CITY OF ISSAQUAH
Development Services Department
URBAN VILLAGE DEVELOPMENT COMMISSION

STAFF REPORT

File No.: **SDP 13-00004**

Project: Bellevue College Site Development Permit

Right: Section from Sht A.4B showing the relationship of College Drive sidewalk to the adjacent building (dashed circle).

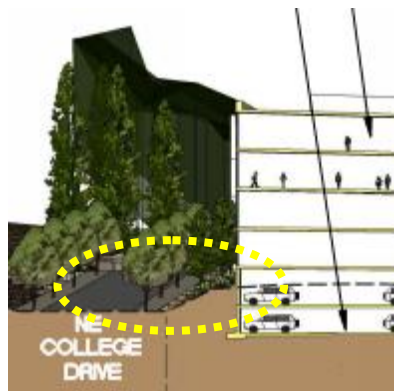
Objective 1.6 describes a connection between Issaquah Highlands, open spaces, and the neighborhoods in the WSDOT TDR. While there is a good network of streets within the campus, there are ways in which the campus could better connect at its edges. Specifically related to this Objective, along College Drive, the north/south section (Sht

A4.B) and the site plan shows that the buildings are setback from the street with buildings much higher than the street, potentially 10-12 ft. And the proposed generic street landscape shown on L.1A would create a heavily wooded band, buffer rather than providing a pedestrian orientation, especially since there is no building entry on this side. At the pre-submittal for the phase in which this landscape edge and these buildings are included, the design must be revised to have a design and orientation which is more pedestrian friendly and welcoming. For instance, move the buildings closer to the street since no setback is required (e.g. around 10-15 from the sidewalk), structure the setback to make it less of a buffer and more of an amenity scaled to the pedestrian (e.g. similar to the Park Dr edge of the 742 reservoir), and design the building to feel open and welcoming even if an entry is not provided on that side (e.g. materials, windows, etc...) **[Condition 7]** This condition is also supported by Objectives 3.2, 3.3, 5.1, 5.2, 6.6; Guidelines 3.1, 3.14.

Left: existing College Dr with curve
Right: Proposed eastern campus entry with roundabout or intersection

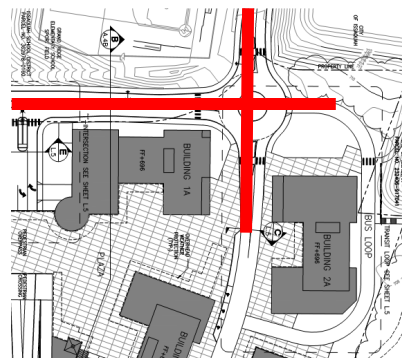
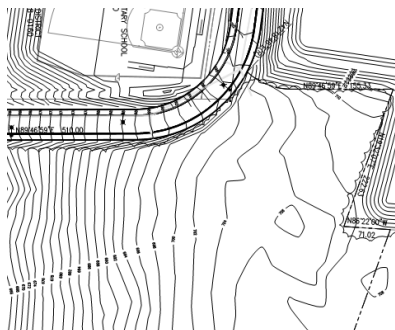
At the eastern campus entrance, the Applicant proposes to rebuild the existing bend at the crest of NW College Drive as a roundabout. The Narrative notes that "During Phase 1 design, the roundabout will be evaluated and a design modification will be incorporated if necessary...." The roundabout may not be necessary and a simple intersection may be simpler and more appropriate, though roundabouts are encouraged by this appendix. This is an effective traffic solution and presents several unique site and building design opportunities, though roundabouts can be challenging to maintain a pedestrian and bike-friendly environment. Though not stated in the application, the main purpose of the roundabout may be to allow cars exiting the eastern campus entry, who must turn right due to the median, to use the roundabout to turnaround and head back west. Since this intersection and the design opportunities afforded by a roundabout will likely lead to this area being an intense pedestrian crossing opportunity, the roundabout must be designed with careful attention to include safe and convenient pedestrian crossings.

The roads must be designed in accordance with the Street Standards shown in the Development Agreement or in accordance with approved modifications to those standards. Not all of the streets shown on the plans meet the current standards (some roads are too wide, some do not have on-street parking, some do not have street trees, etc.) however, it is assumed that during utility permitting the road designs will be further developed to be compliant. It is not anticipated that the revisions necessary to comply with the street standards will have a significant impact on the design, location or usability of any of the adjacent building or pedestrian facilities.

Illustration of possible segregation of vehicular and pedestrian/bike facilities in eastern portion of the campus.

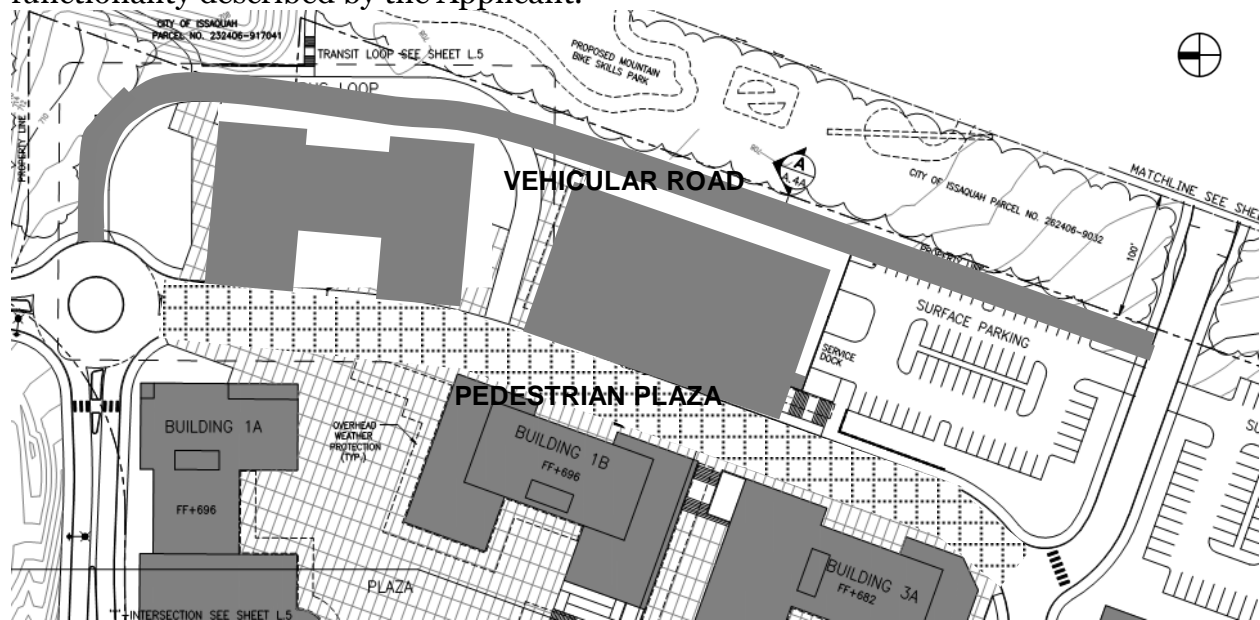
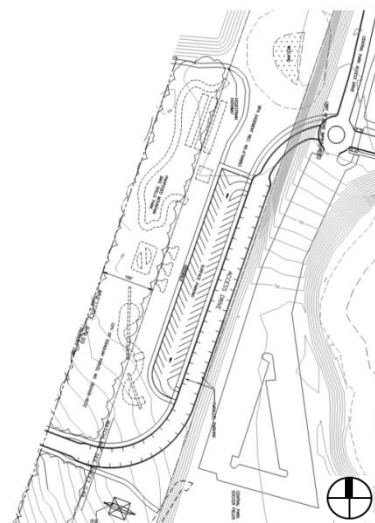
The roads proposed for the loop meet adopted standards or can be modified to meet standards. At the same time, the Applicant is encouraged to consider dividing the various purposes of the Upper Loop Road into two separate facilities: vehicles would be served by a road along the eastern property line; pedestrians and bicycles would be served by a linear plaza where the Upper Loop Road is currently located. This will allow the majority of the traffic on the Loop Road to use the eastern route to minimize the number of cars between buildings 1a and 2a, an intense pedestrian zone. This modification would be a consideration, not a requirement, intended to better meet the functionality described by the Applicant.

Left: Parking garage entry through a surface parking lot Right: Entrance to under-building parking, close to College Drive

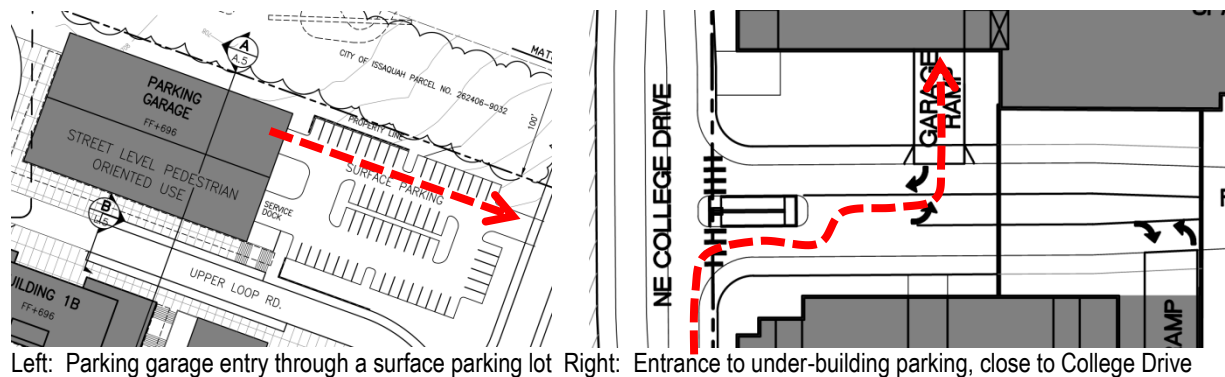
The design of the roads and garages is integral to their functionality, and ensuring that queued cars don't impact public rights-of-way or basic functionality. For instance, the location of the northernmost garage entry from the Lower Loop Road is fairly close to College Drive. Cars waiting to use this entry may not back up onto College Drive. During the preliminary review of the phase which would construct this garage entry, the Applicant must provide a traffic study to determine if the garage entry is in the correct location or if it must be shifted to the south. Likewise, the design of the structure parking garage entry, uses a surface parking lot to consolidate vehicle parking and queuing. While combining these similar uses minimizes their impact on pedestrians, it may negatively impact the surface parking's function. That is, cars queued to exit the garage and surface parking, will block the parking along this row, indicating that the parking should be parallel or removed. **[Condition 16]**

Proposed parking area within BPA Easement Area

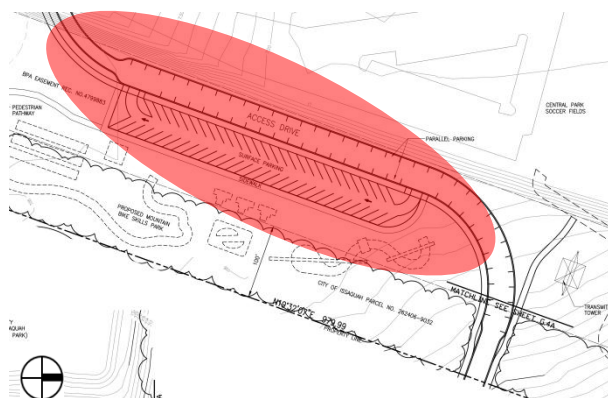
The application narrative discusses the potential for approximately 115 parking stalls to be located within the Bonneville Power Administration (BPA) easement corridor located immediately east of the Property. Bellevue College does not hold ownership to this parcel and there is not an agreement in place to allow parking within the easement area. Therefore, required parking for the project cannot be counted within the BPA easement area. Until such time that Bellevue College obtains permission from BPA to construct parking stalls within the easement, the proposal must demonstrate that all required parking can be accommodated on site. This is acknowledged in the application narrative which states that “BPA surface parking will reduce the number of spaces needed from free standing parking garage” (p. II-I).

Based upon the proposed parking phasing, any potential BPA parking would be constructed with Phase 1B of development. As such, the quantity of parking stalls provided within the parking garage will be dependent upon whether or not permission can be obtained from BPA to utilize their easement area for the provision of parking. The expectation is that if parking cannot be provided within the easement area, the necessary parking stalls would be constructed within the parking garage to meet the parking demand as required by the Development Agreement. **[Condition 17]** Because these stalls are provisional, they have not been reviewed for consistency with code requirements, though some internal landscape would be required per Guideline 2.72.

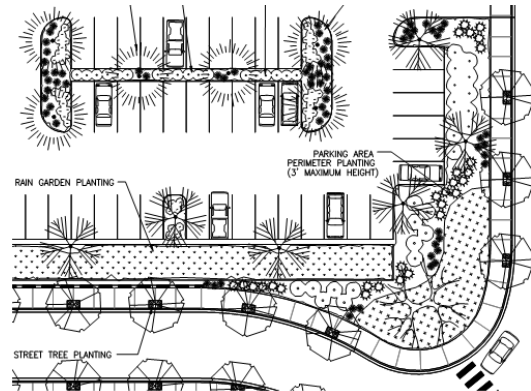
Sht L-6, shown to right, portrays the concept for parking lot edge landscaping. Though minimal detail is shown, it doesn't appear that it provides the minimum 40" high landscape screening or walls that achieve a minimum of 75% opacity at the time of construction/planting. (Note that for safety, landscape may be maintained so that 40" is the maximum height.) In addition, many guidelines require landscape along the edge, internally, and adjacent to walkways; these can be addressed with Construction Conditions, **Attachment B**. For the purposes, of the parking garage, if the roof is used for parking (it is not pictured this way in the submittal), then the roof will be treated like a parking lot and landscape standards and guidelines will apply. **[Condition 24]**

continuous and at least 40" in height. Alternatively, screening may be either living (planted) or a wall, but must achieve a minimum of 75% opacity at initial construction/planting. This standard shall also apply to rooftop parking decks if they are used.
